Bedroom 1's bathroom · design review F-05 · accept the route (A) or a private bathroom (B)? · Taif / Palm House · A ADOPTED · B NOT ADOPTED: young children's room (owner, V9.0)

OPTION A ADOPTED by the owner (2 Nov 2026): no private bathroom; the wet areas stay grouped in the two clusters; night lights along the route. 2 Nov 2026, after the stair flip (option B, F-b) · bedroom 1 is the north-east room over the maid wing, 15.75 m² on axes, 13.9 m² clear, one room without a bath · nothing in the design files changes until the owner decides · all sizes assumed

bedroom 1 · A · 1 m = 0.95 cm · north up · brown dotted = the ground floor below

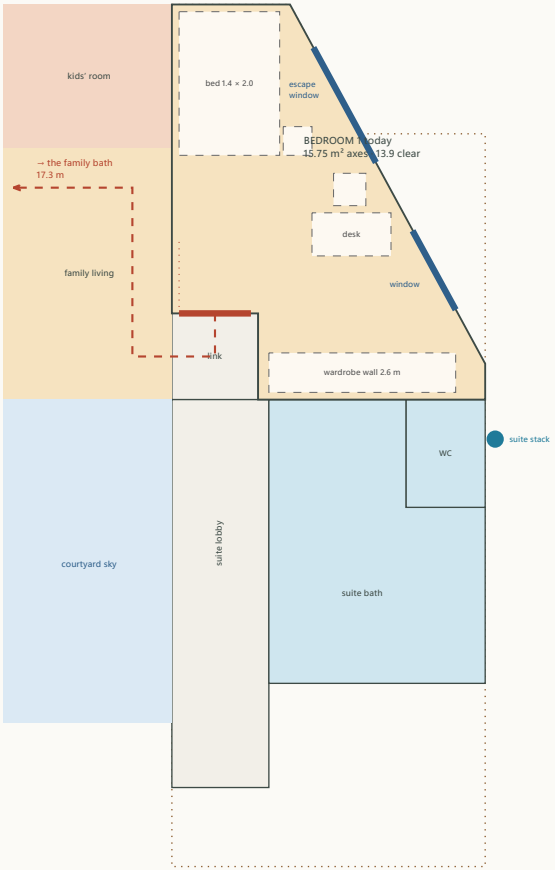
Option A · accept the route

- **The walk, measured after Part 1** (the stair flipped, the family bath enlarged northwards; its door stays at x 4.25, y 9.3–10.3): bedroom 1's door → the family link → the family living, behind the sofa → the gallery's north part, past the stair arrival → the gallery → the bath's door: **17.3 m** (the same as before the flip: the bath grew, its door did not move). Five spaces, two of them lived in (the living, the gallery).

- **Who shares the family bath:** bedroom 1 (17.3 m), bedroom 2 (2.7 m), the kids' room and the family living (a bedroom later); bedroom 3 and the suite have their own. Since F-b it has **two compartments** (a WC by the shaft and the shower + double basin), so two children at once.

- **Comfort:** a child or a guest in bedroom 1 crosses the **family living** at night and in the morning, in sight of whoever is there; 17 m is the longest bathroom walk in the house (the suite's is 0, bedroom 3's 2.7, bedroom 2's 2.7).

- **Cost:** nothing; the plumbing stays as it is.

bedroom 1 · B2 · 1 m = 0.95 cm · north up · brown dotted = the ground floor below

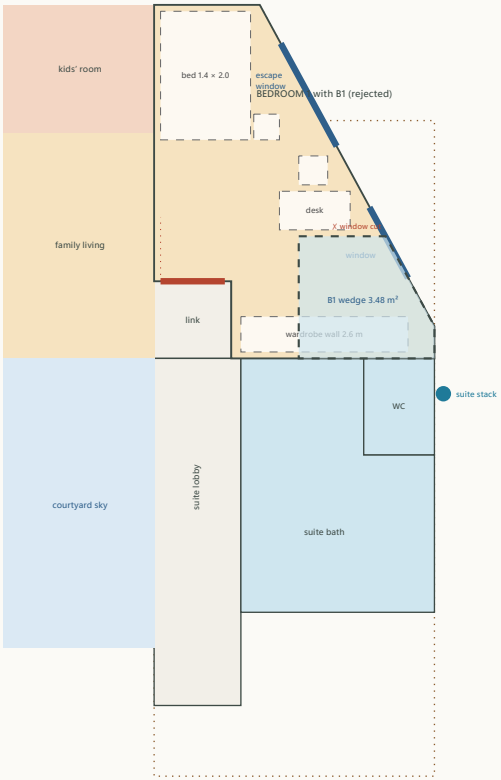
- **B2 (the best, drawn):** a bath along bedroom 1's **south wall**, x 10.6–13.311, y 5.0–6.5, its east end following the cut wall: **3.79 m² on axes, 2.49 × 1.3 clear less the slant ≈ 3.0 m²**: a walk-in shower 0.9 × 1.2 at the east end (its corner 0.02 m west of the cut wall), the WC in the middle facing north, the basin on the west wall, a **sliding 1.0 m door** from the room (no swing), a **small window on the cut wall** (y 5.35–5.85, sill +1.60, obscured). It is **next to the master suite's wet stack**: the pipes run 2.5 m east in the bath's own floor zone to the suite's stack outside the east wall (y 7.05), **over the GF maid room only** (the kitchen and its hood zone start at y 7.0; nothing over the master bedroom).

- **Bedroom 1 with B2: 11.96 m² on axes, ≈ 10.3 m² clear** (was 15.75 / 13.9): the bed 1.4 × 2.0 stays on the west wall with its bedside table, the desk and chair under the escape window, the wardrobe wall (2.6 m) becomes **two wardrobes, 1.3 m on the bath's wall and 0.9 m on the west wall** (2.2 m in all); the door's swing stays clear; the **escape window stays the room's** (the fire study unchanged); the second window (y 4.15–5.25) lights the desk. Still a full bedroom (a 1.4 bed, a desk, 2.2 m of wardrobe), no longer a two-bed room.

- **Drain:** the shower, the WC and the basin to one branch running east along the bath's south side to the **suite's stack** outside the east wall (y 7.05), 2.5 m; the branch crosses the room's south wall line at x 13.311 and turns south outside the wall for 0.6 m (or a second stack beside the suite's; the MEP engineer). **Over the GF maid room only**: not over the kitchen (y ≥ 7.0), its hood zone (the east wall y 10.2–11.2) or the master bedroom (x 8.95–13.311, y 11.9–19.25).

- **Structure (`studies/structure.typ`):** the maid wing's first-floor bay is a **solid 0.20 slab** spanning east–west 4.36 m to the cut wall; a 0.15 depressed zone cannot be cut from 0.20. Two ways, the engineer's choice: **(i)** cast the bay 0.35 thick under the bath with its top depressed 0.15 (as the suite bath, X10), or **(ii)** keep the slab and run the pipes **below** it in the maid room's ceiling void (the maid room gets a gypsum ceiling anyway; 3.1 m clear left) with a wall-hung WC and a shower tray raised ≈ 0.10. The bath's walls are light partitions on the slab (no beam; B6 at y 6.5 is the room's south wall beam, untouched).

- **Windows:** the bath's small window on the cut wall faces the lane side (obscured glass, a vent); the room keeps both its windows. **Ventilation:** the window plus an extract fan to the roof riser is not available here: an extract through the cut wall (a small louvre) or a duct in the ceiling void to the east wall.

- **Neighbours:** the maid room below hears the bath (pipes in a ceiling void: wrap them); the suite's WC closet shares the stack; the family link and the suite lobby are untouched; the family bath keeps serving bedroom 2, the kids' room and the living.

Recommendation: B2, if bedroom 1 is to be a guest room or an older child's room; otherwise A

- The route is the longest in the house and crosses the living: that is the real cost of A, and the only one. B2 answers it for ≈ 3 m² of the room and one more wet room; it is the only tidy position (B1 is a wedge that cuts a window, B3 takes the escape window). **Conditions for B2:** the engineer chooses the slab detail (i) or (ii); the MEP engineer the stack connection and the vent; the wardrobe split accepted.
- **If A:** keep the family bath as F-b (two compartments) and note in the house rules that bedroom 1's user has the family bath; nothing else to do.

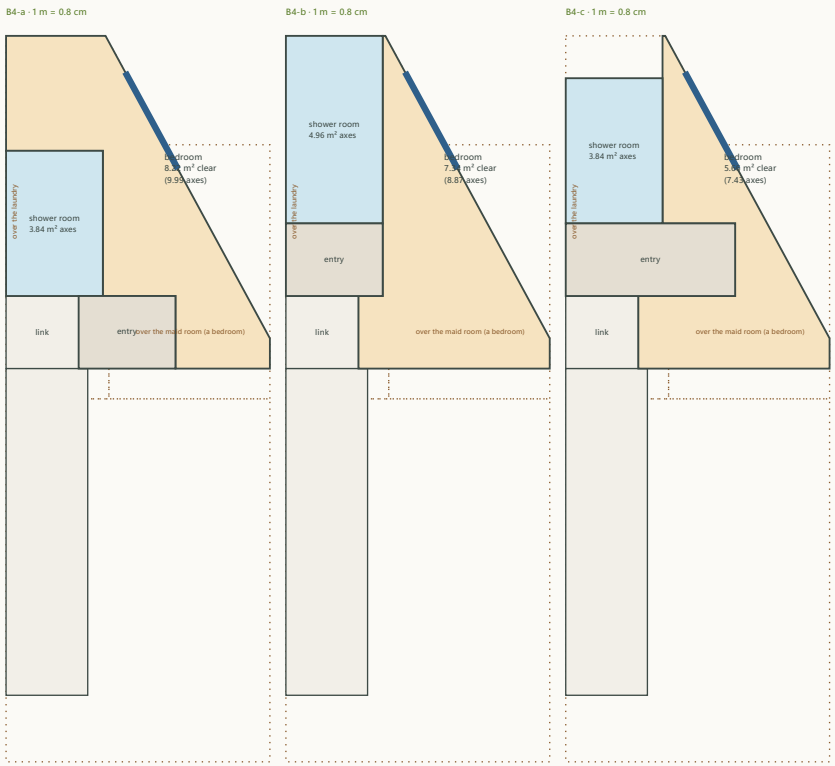
- **B1 (the south-east wedge, dashed on page 2):** x 11.2–13.311 on the cut wall, 3.48 m²: a wedge, its north wall cuts the second window (y 4.15–5.25) and leaves 0.8 m of the wardrobe wall: worse than B2 for the same plumbing. **B3 (the north-east corner):** the north-east corner (x 10.6–12.0, y 1.0–2.9) holds the room's **escape window** and the bed's head wall: a bath there moves the escape window and the bed; rejected without drawing.
